Truro Board of Health

Tuesday January 17, 2023
Remote Meeting- 4:30 PM

Proposed Sewage Disposal System 108 Slough Pond Rd., Truro, MA	
Prepared for: Jeff Halpin, Tr. 104 Irving St. Cambridge, MA 02138	CSN ENGINEERING P.O. Box 201 Brewster, MA 02631 Phone: (508) 274-7347
DATE: 1/02/2022	SCALE: AS SHOWN
DESIGN: LIC	CHECK: RM
JOB NO: 2021316

To: Truro Board of Health
From: Emily Beebe, Health & Conservation Agent
Date: Jan 13, 2023
Re: January 17 meeting: septic upgrades- review notes

SEPTIC SYSTEM UPGRADE PLAN

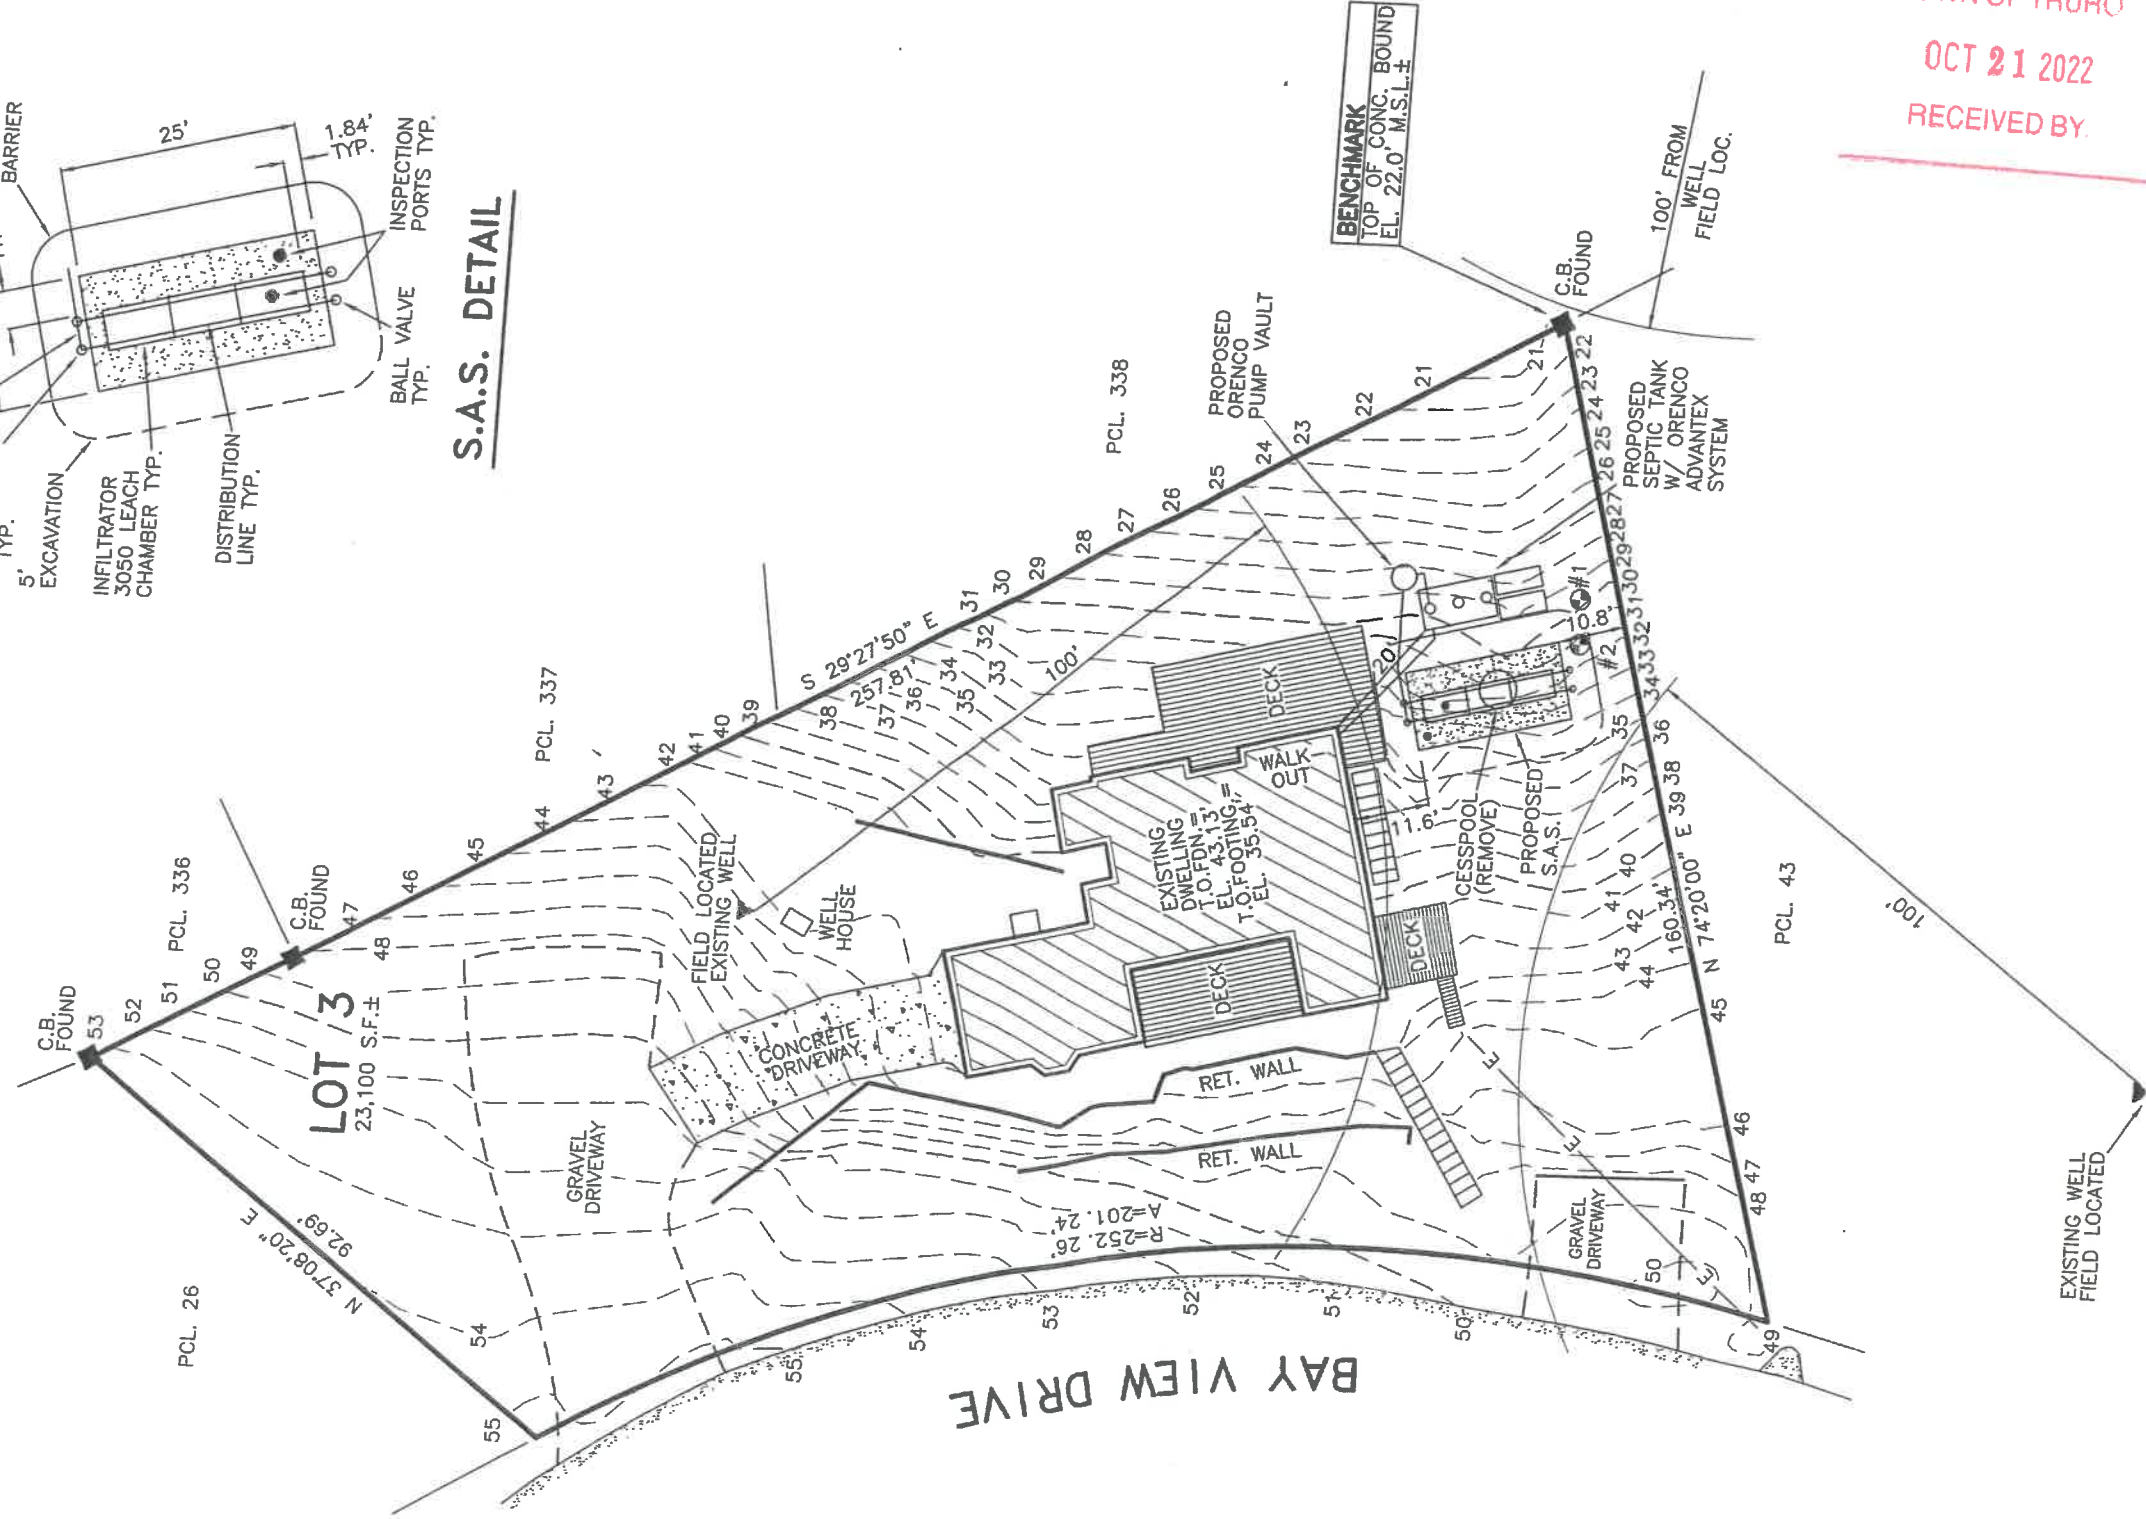
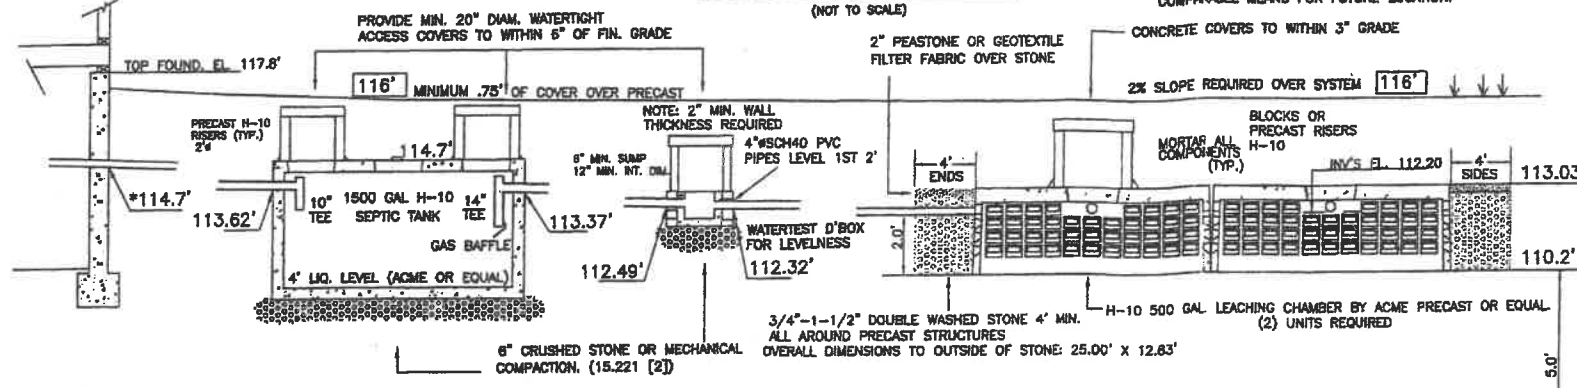
18 Bay View Drive

This project was originally heard on Nov. 1 and was continued for staff to resolve the bedroom count issue with the owner, or representative. This septic upgrade should be designed for a 4 Bedroom dwelling, which is what currently exists on the 23,100-sf parcel.

- Assrs. card specifies 4 BR; the house was built as a 3 BR in 1971.
- A walk-through has been conducted by our office:
 - There is a finished second-floor garage space, not legally finished as a BR, that meets the definition of a bedroom and has a bed in it;

- There is a finished basement with 3 BR observed. None of these meet the requirements of the building code, regarding egress windows.
 - There is a bedroom on the main floor with the kitchen, living room and dining room.

- It is recommended that a deed restriction be crafted to specify the approved BR count (4) for the property. The owners must submit a plan describing how they will reconfigure the space for only 4 bedrooms and how they will create building code conforming egress for the basement bedrooms. We also recommend requiring a deed restriction.

- There are no title 5 variances, however, the existing use on this lot size triggers the use of I/A technology. An Orenco Advantex AX-20 was proposed.

- A 38% reduction to the size of the leaching area was proposed; this is allowed under the general use approval for the Advantex system.
- It appears that GW flow is toward the east, and the arrangement of the locus well and SAS is parallel. No wells in this area appear downstream of the SAS.

- **The Variance requested is to the time frame for completion of the upgrade to title 5 from a cesspool.**
